**Re: SPK-200600897-SA
Colusa Generating Station Project
Update to 404 Permit Application**

E&L Westcoast, LLC, has refined and revised the proposed Glenn-Colusa Canal Bridge replacement and road alignment for the Colusa Generating Station Project (Figure 1) to address recommendations by adjacent property owners. A full discussion of the new proposed bridge design is provided in the enclosed report entitled Proposed Modification to Glenn-Colusa Bridge design.

REVISED GLENN-COLUSA CANAL BRIDGE AND STAGING AREA

Colusa Generating Station
E&L Westcoast, LLC
Colusa County, California

FIGURE 1

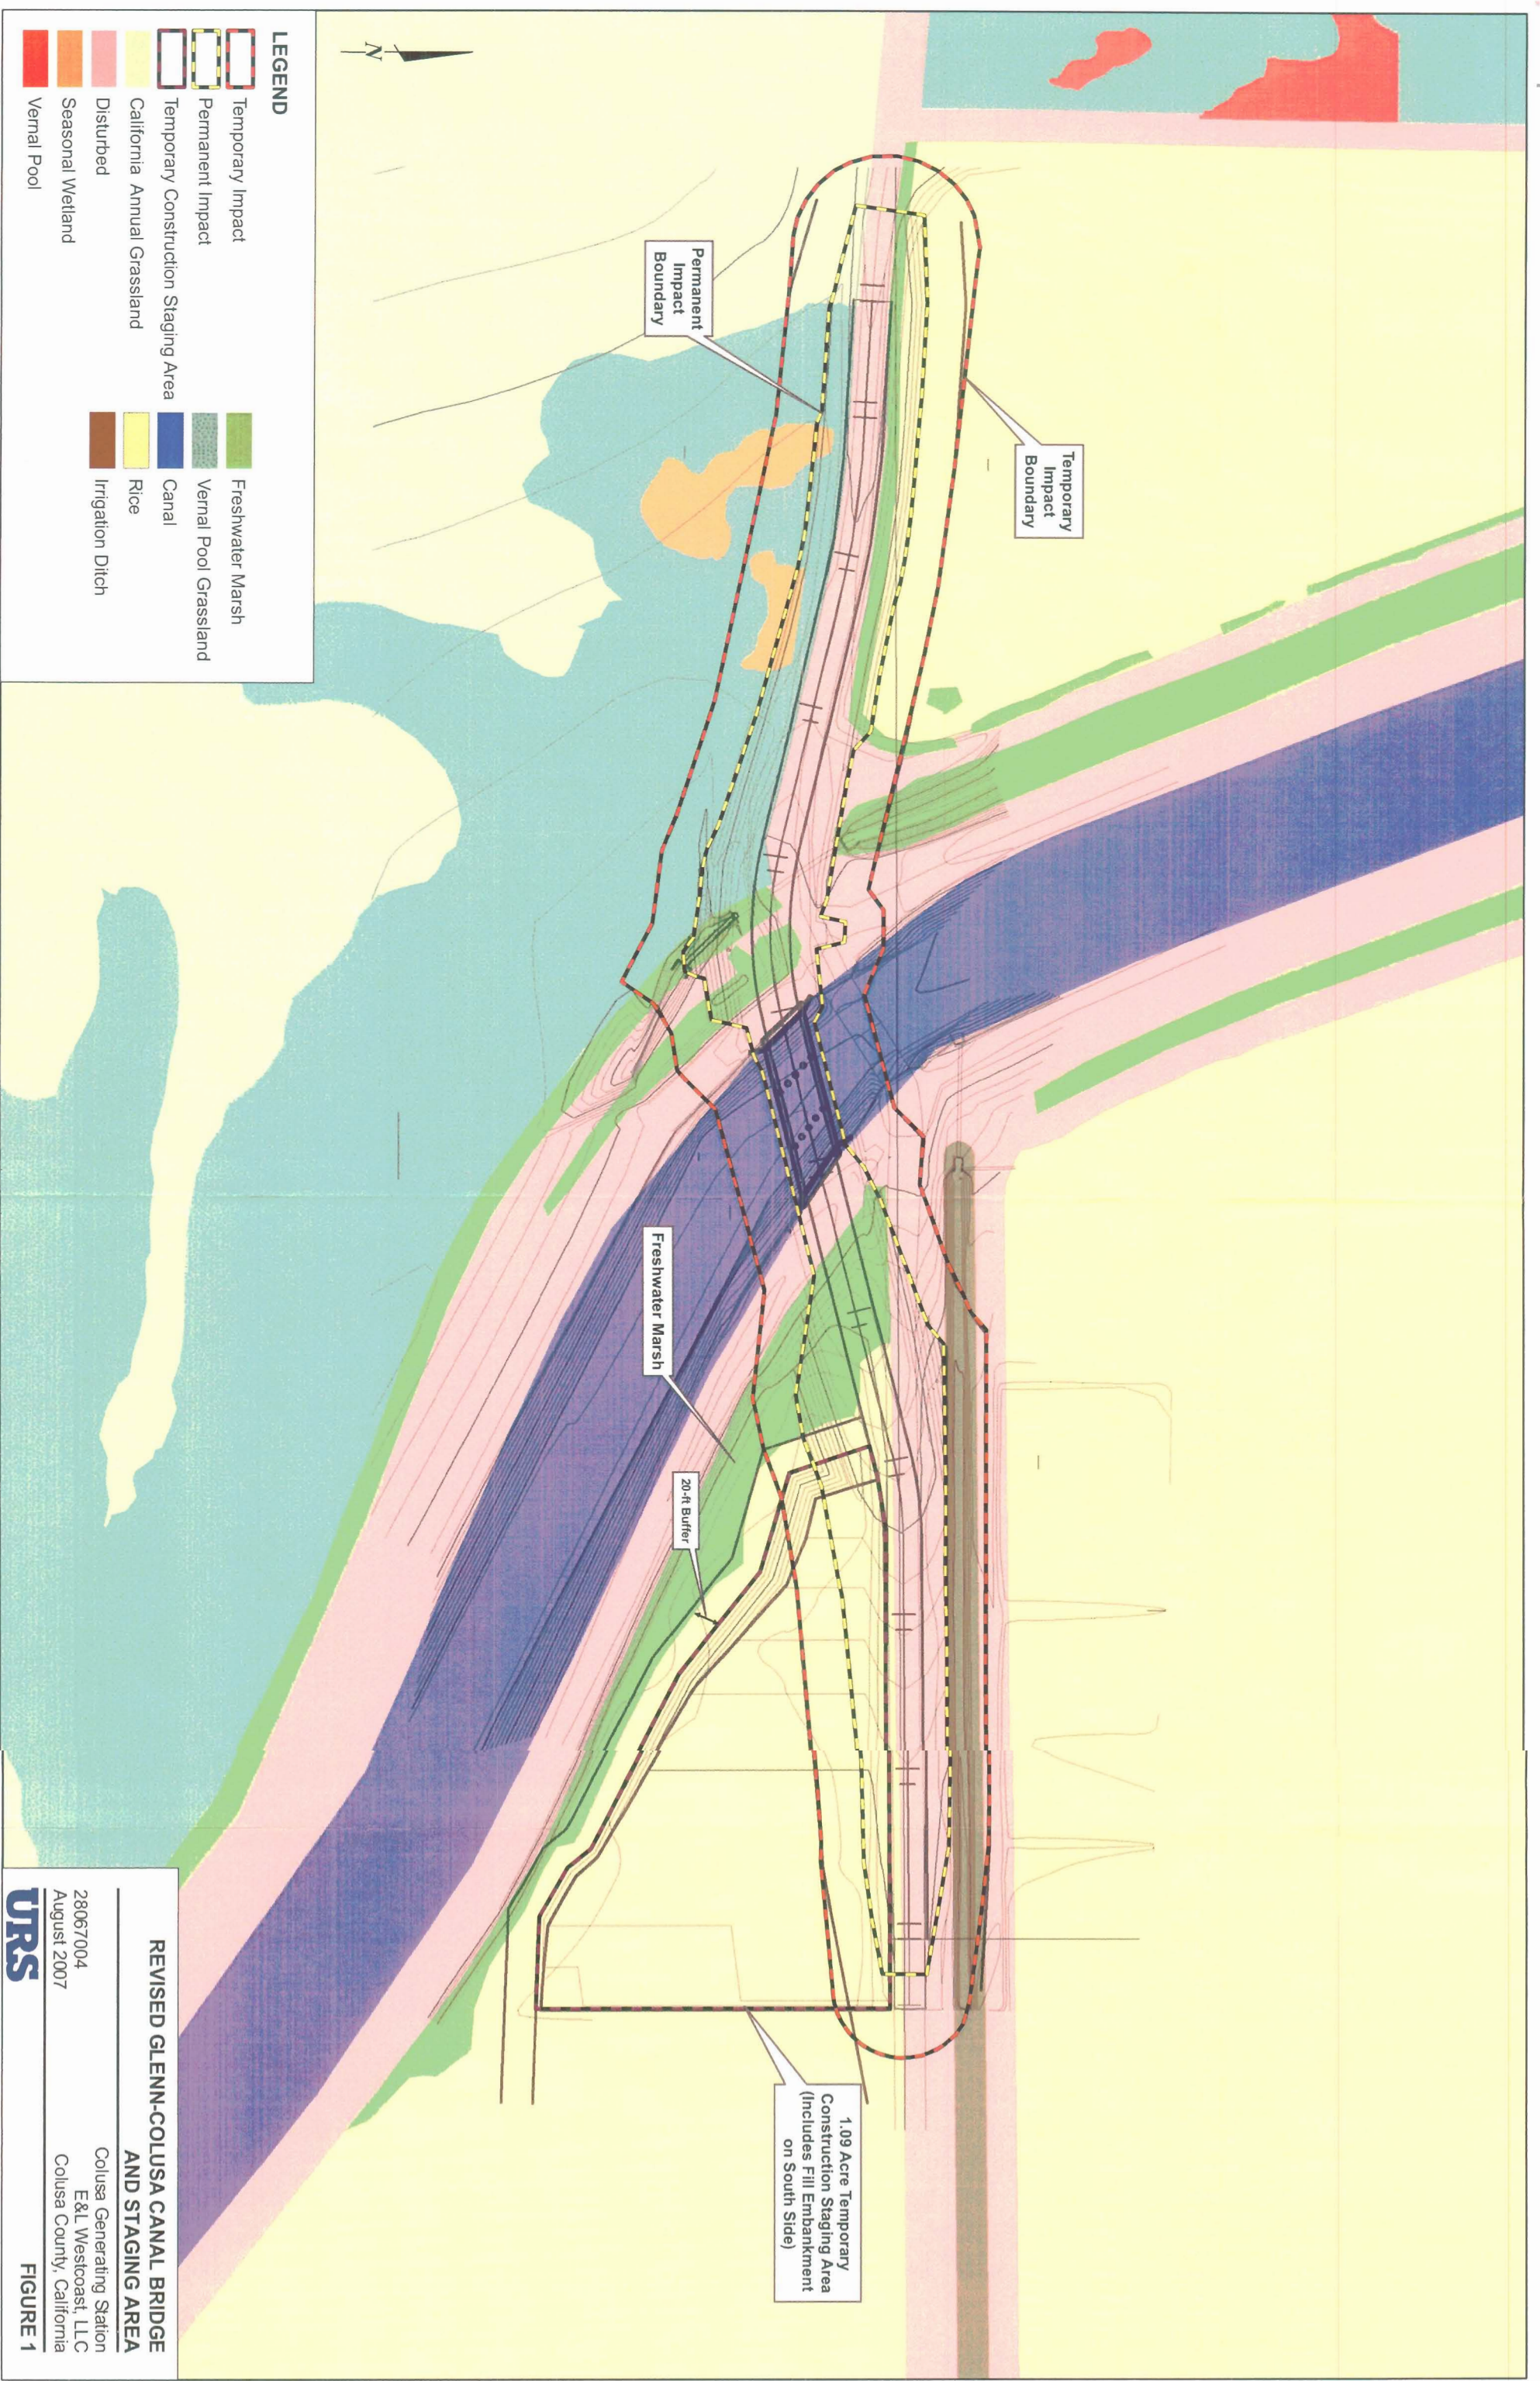
On behalf of E&L Westcoast, LLC, this letter summarizes the new design and provides revised estimates of the potential impacts and mitigation for the proposed project. These estimates replace the information provided in the submittals transmitted to the Corps on April 5, 2007 and May 24, 2007. The following components of the Standard 404 Permit Application have been revised to address the change in bridge design:

Because the new bridge design does not affect any areas not already discussed and included in the Wetland Delineation previously provided to you for this project, we believe that the Corps concurrence with that delineation, dated August 10, 2007, does not need to be revised.
